INDIANA DEPARTMENT OF TRANSPORTATION

STANDARDS COMMITTEE MEETING AGENDA

RE: Agenda for the March 15, 2007 Standards Committee Meeting

49-5.01(04) Guardrail and Embankment Slopes

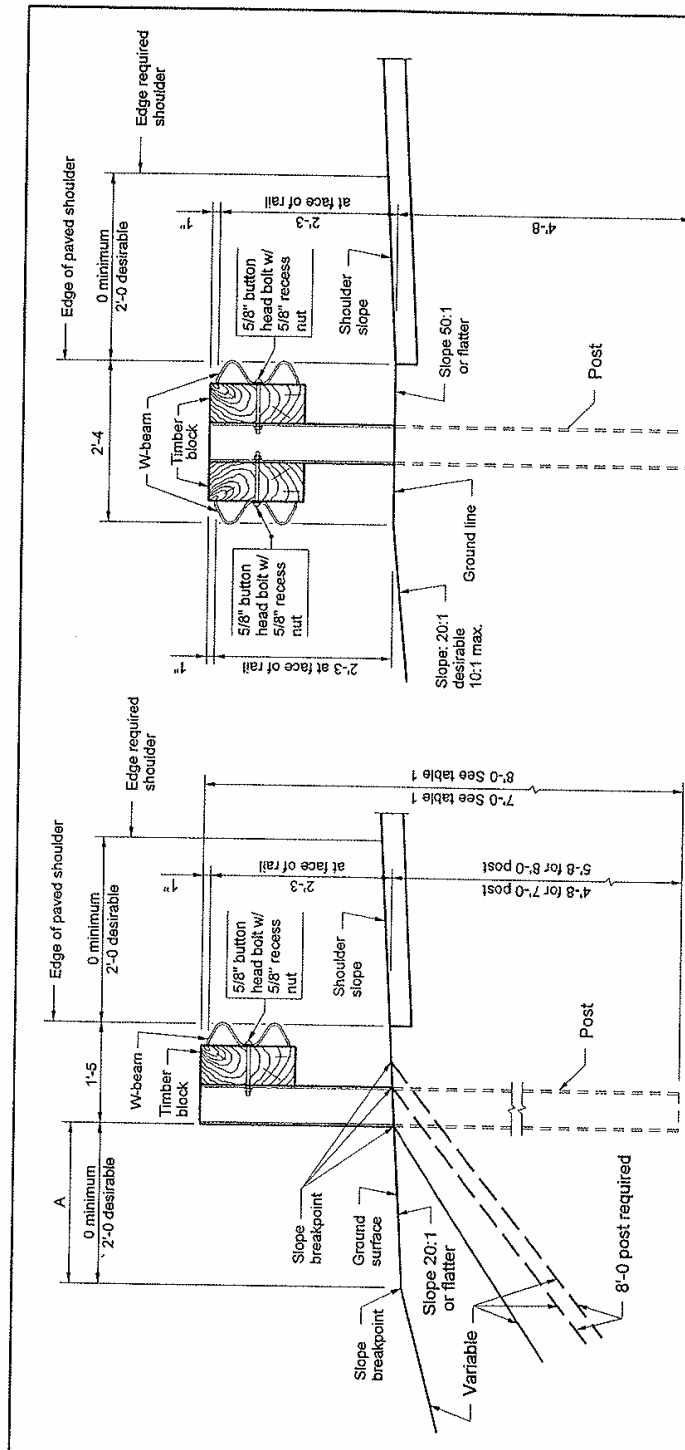
The shoulder slope to the front face of a semi-rigid barrier should desirably be between 10:1 and 20:1; however, in no case, should that slope be steeper than 6:1.

The W-Beam guardrail post embedment length must be appropriate either in cohesive or cohesionless soil. The INDOT Standard Drawings present the criteria for location of the guardrail post and the required post embedment length for the corresponding location of the post on a graded shoulder. A 0.6 m (2'-0") distance on the graded shoulder before the shoulder slope break point, as measured from the back face of the guardrail post, is desirable for adequate soil foundation support. Where site conditions dictate a graded shoulder width behind the back face of the post less than 0.6 m (2'-0"), the guardrail post length should be 2.13 m (7'-0"). Where site conditions dictate that the front face of the guardrail post must be located at or beyond the shoulder break point, the guardrail post length should be increased to 2.43 m (8'-0") to compensate for the reduced soil foundation support.

Where guardrail posts must be placed on steep shoulder slopes (1:1 or 2:1, etc.) or in aggregate shoulder wedges greater than 75 mm (3") thick adjacent to the edge of the effective usable (paved) shoulder, the 2.43 m (8'-0") post discussed above should be used to provide adequate foundation support for the guardrail post.

INDIANA DEPARTMENT OF TRANSPORTATION	
W-BEAM GUARDRAIL ASSEMBLIES	
MARCH 2007	
STANDARD DRAWING NO. E 601-WBGA-01	
DESIGNED BY Richard L. VanCleave DESIGN STANDARD ENGINEER	CHECKED BY Richard L. VanCleave DESIGN STANDARD ENGINEER
DATE 3-01-07	DATE 3-01-07

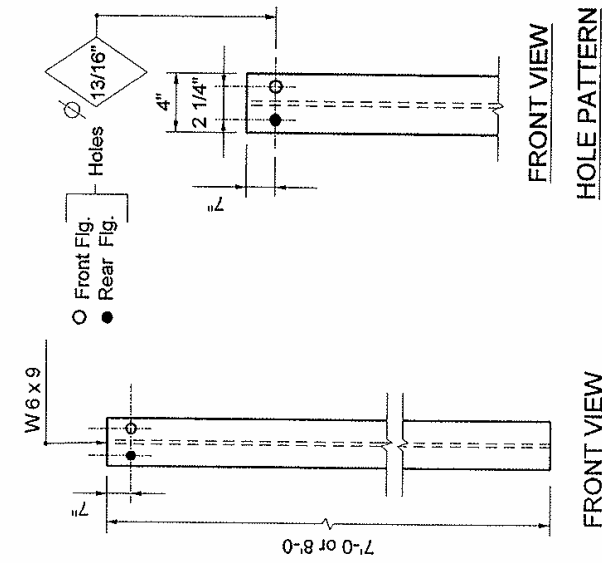
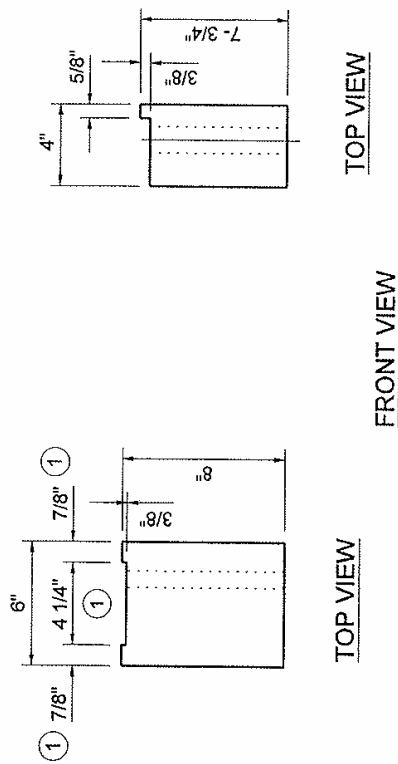
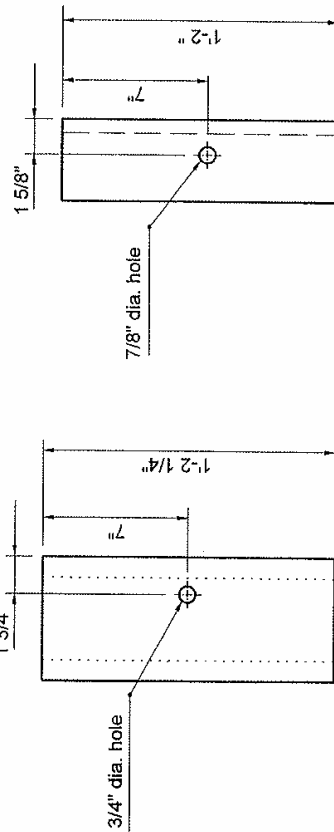
The following Standard Drawings, both metric and English, for W-Beam guardrail were revised to incorporate additional information to aid designers in selecting an appropriate W-Beam guardrail post length where the distance from the back face of the guardrail post to the slope break point on a graded shoulder is less than the desirable 0.6 m (2'-0"):

601-WBGA-01, W-Beam Guardrail Assemblies
601-WBGC-03, W-Beam Guardrail Components

1. For new projects or where the distance A is known, the appropriate embedment length shall be used for the selected post length.

*TABLE 1 Guardrail Post Length Selection for Installation at shoulders			
Distance A	Post Length	Embedment Length	
A = 0'-0" to 2'-0"	7'-0"	4'-8"	
Shoulder break point at or in front of the front face of guardrail post	8'-0"	5'-8"	
On steep shoulder slopes 1:1 or 2:1	8'-0"	5'-8"	
In aggregate wedges adjacent to the edge of the effective usable shoulder <i>3" thick or greater</i>	8'-0"	5'-8"

GUARDRAIL POST AND EMBEDMENT LENGTH COMPARISION WITH OTHER DOTs

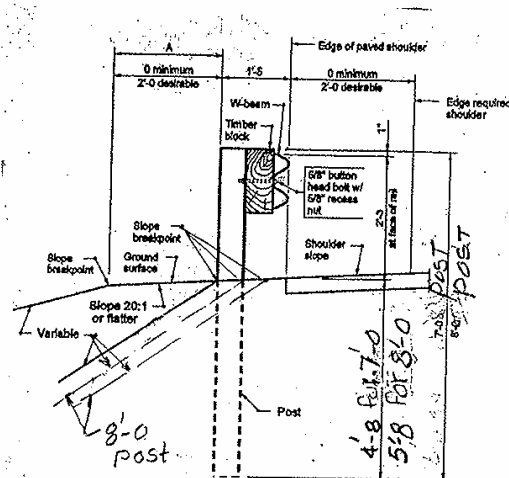
DOT	Distance A	Post Length	Embedment Length
INDOT Current	A = 0' min. 2'-0 desirable	7'-0	4'-8
INDOT Proposed	A = 0'-0 to 2'-0	7'-0	4'-8
	Shoulder break point at or in front of GR post.	8'-0	5'-8
	On steep shoulder slopes	8'-0	5'-8
	In aggregate wedges	8'-0	5'-8
OHIO	A ≥ 2'-0	6'-0	3'-8
	A < 2'-0	7'-9	5'-5
MICHIGAN	A = 2'-0 min. required	6'-0	3'-8
	if A = 0' (at shoulder break point)	8'-0	5'-8

INDIANA DEPARTMENT OF TRANSPORTATION	
RAILROAD CROSSING DETAILS HMA INTER TRACK HEADER	
STANDARD DRAWING NO. E 614-RRGC-03	SEPTEMBER XXXX
DESIGN STANDARD ENGINEER	DATE
CHIEF HIGHWAY ENGINEER	DATE

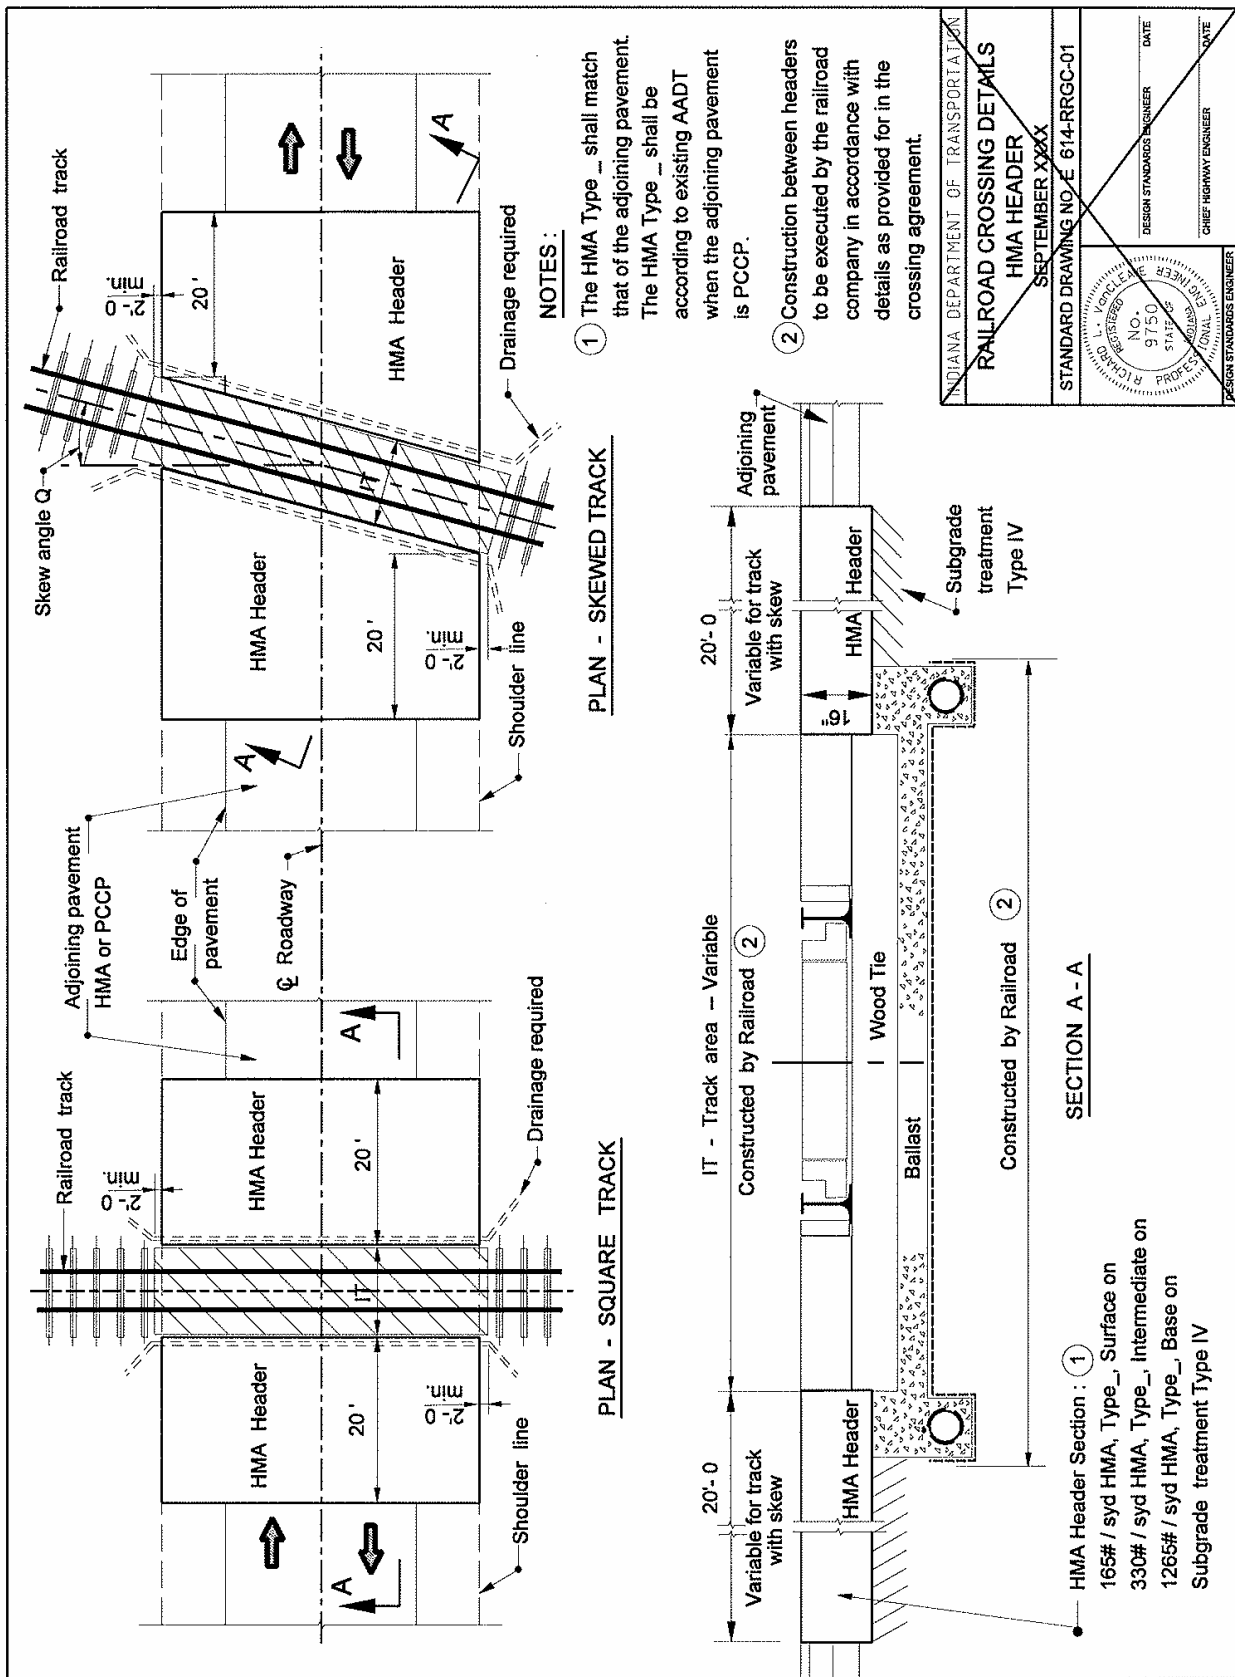
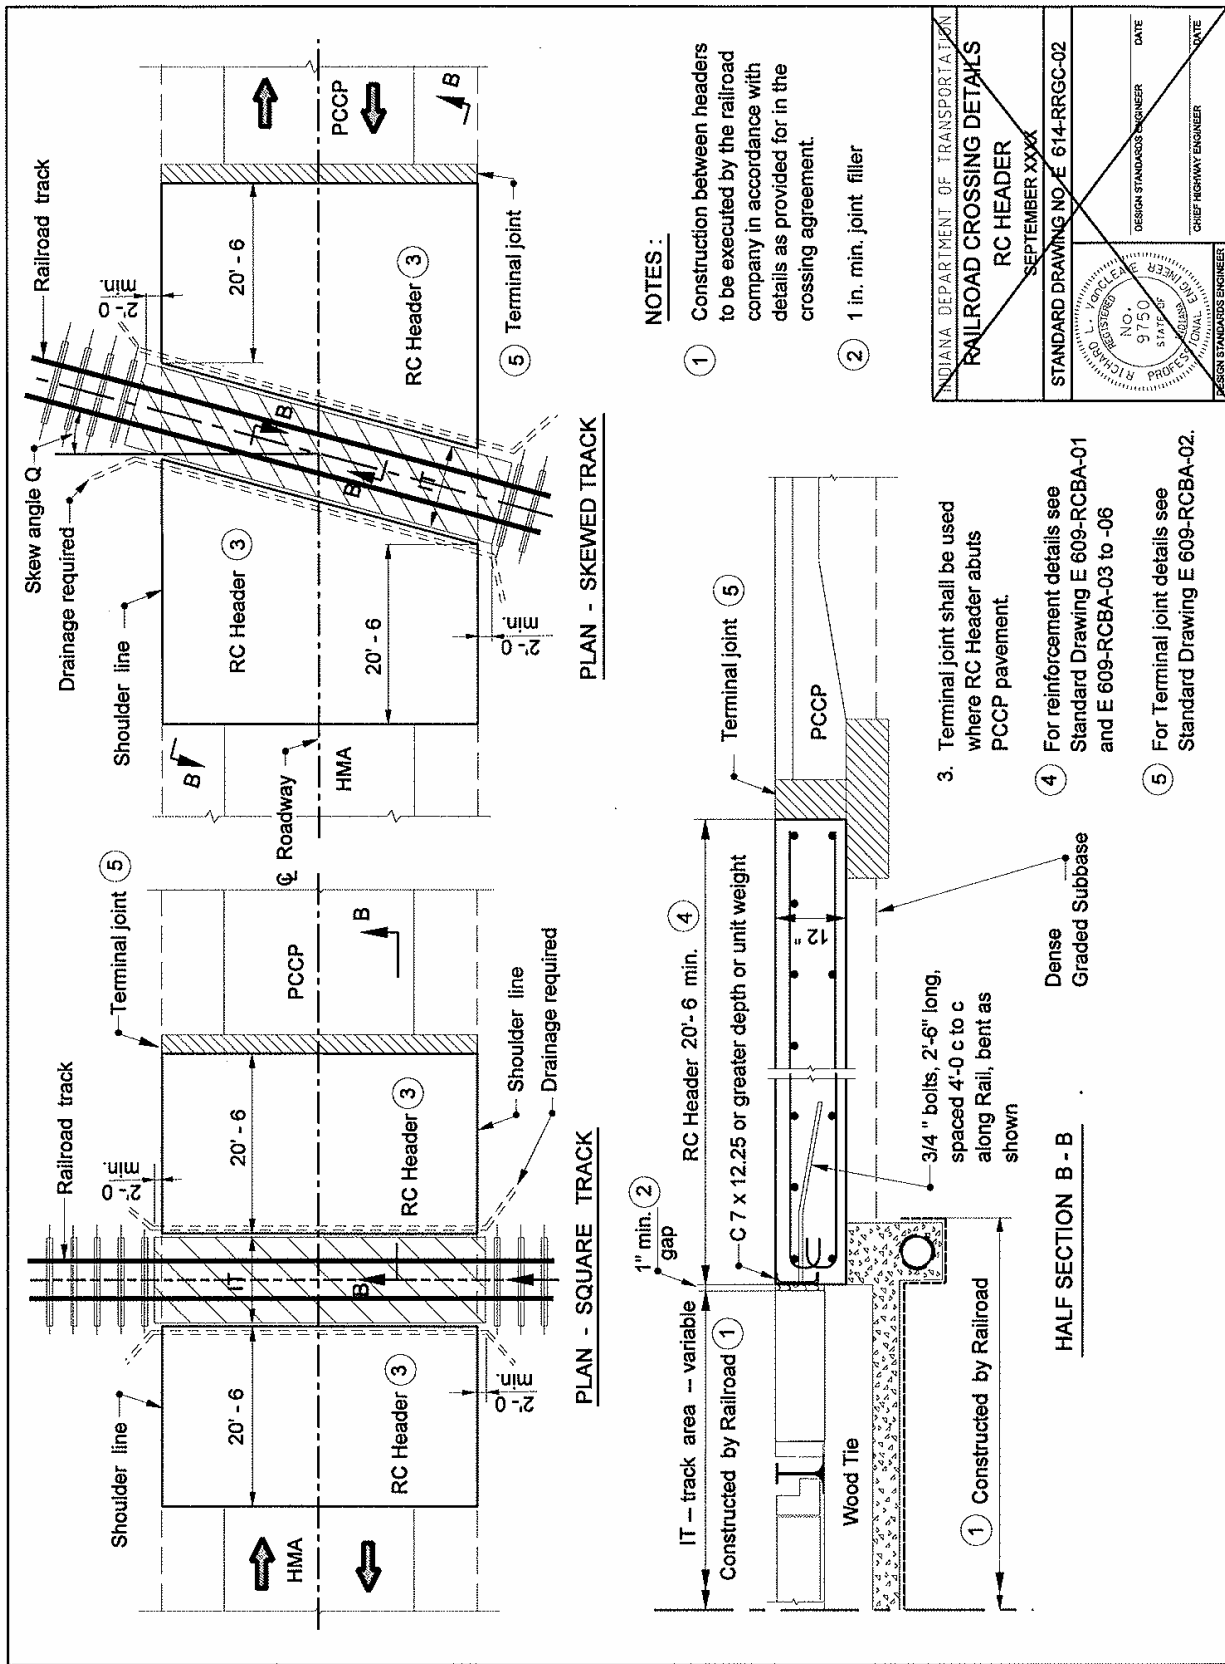
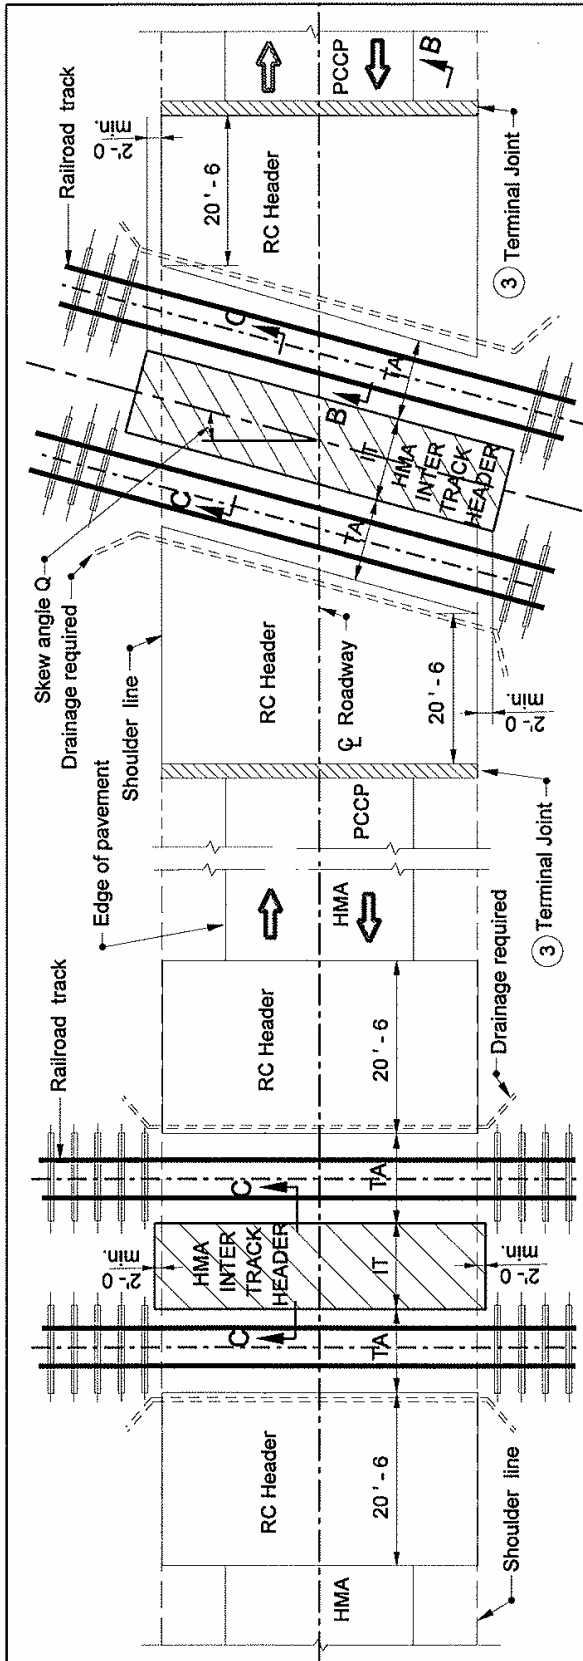
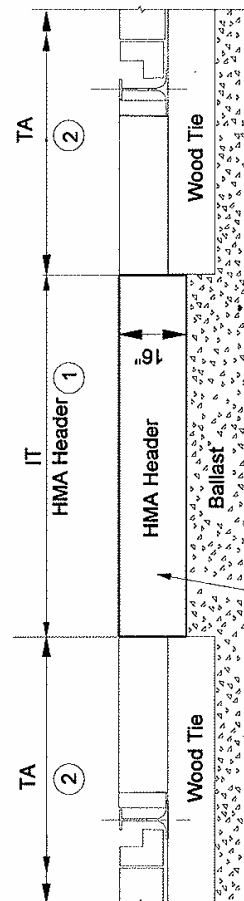
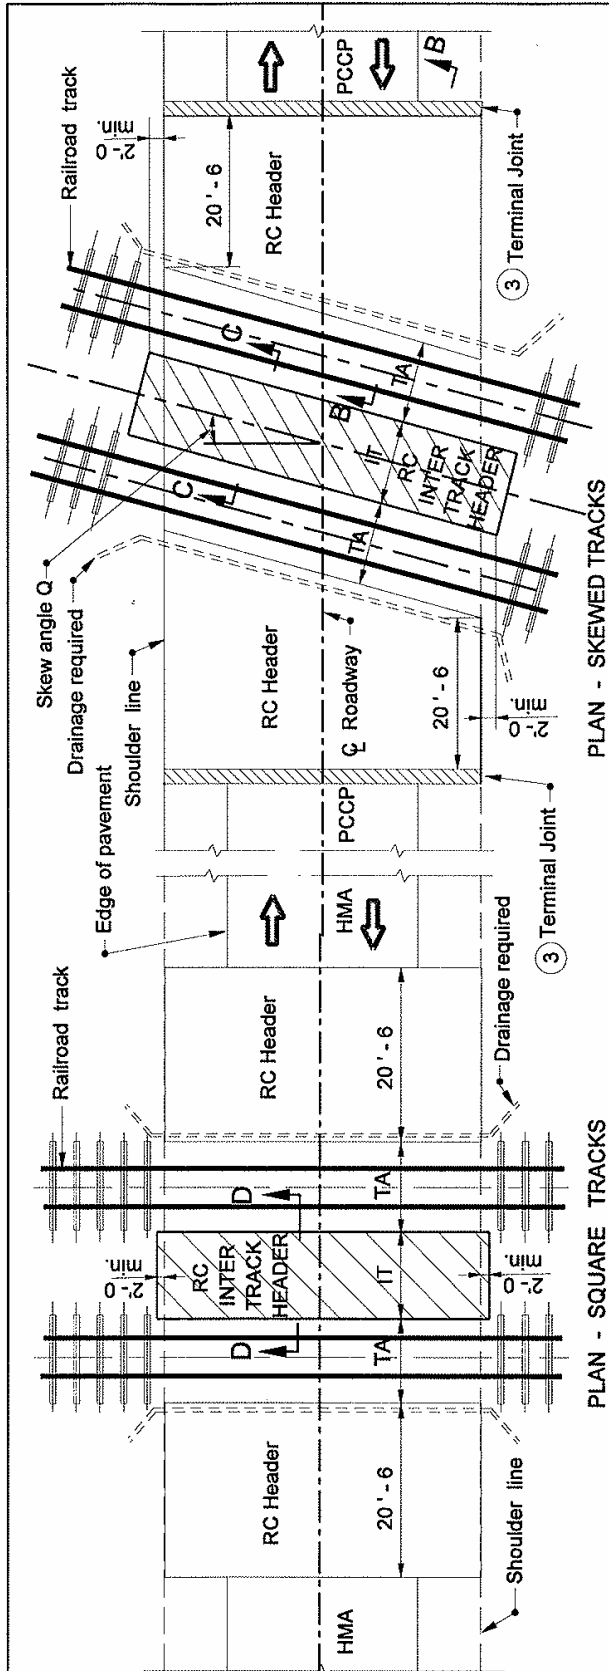
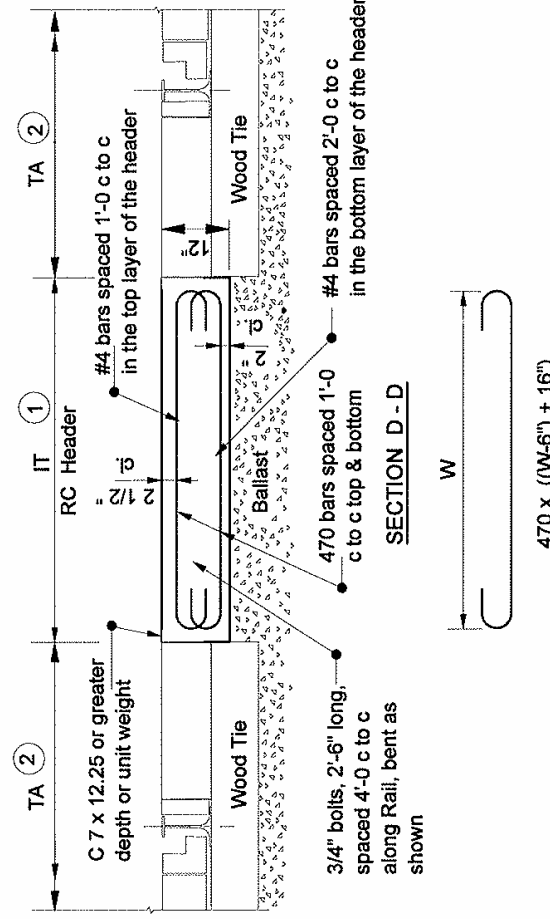
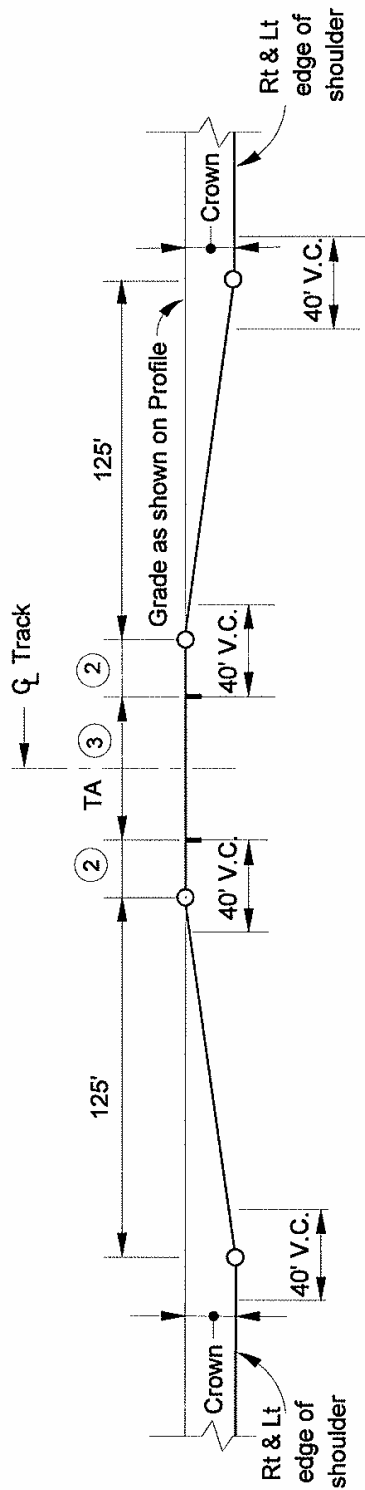
The following are proposed new standard drawings:

614-RRGC-01, Railroad Crossing Details, HMA Header
614-RRGC-02, Railroad Crossing Details, RC Header
614-RRGC-03, Railroad Crossing Details, HMA Inter-Track Header
614-RRGC-04, Railroad Crossing Details, RC Inter-Track Header
614-RRGC-05, Railroad Crossing Details, Crown-Out Diagram

- ① See Standard Drawing E 614-RRGC-04 for RC INTER TRACK HEADER.
- ② Construction between headers as indicated on the drawing to be executed by the railroad company in accordance with details as provided for in the crossing agreement.
- ③ Terminal joint shall be used where RC Header abuts PCCP pavement.
- ④ See Standard Drawing E 614-RRGC-02 for the details of RC Header and Section B - B.
- ⑤ The HMA Type shall match that of the adjoining asphalt pavement.
HMA Type shall be according to existing AADT when the adjoining pavement is PCCP.

- ① Crown shall be taken out of pavement at each railroad crossing.
- ② 20 ft or as required due to track skew.
- ③ TA is a track area to be constructed by railroad company.
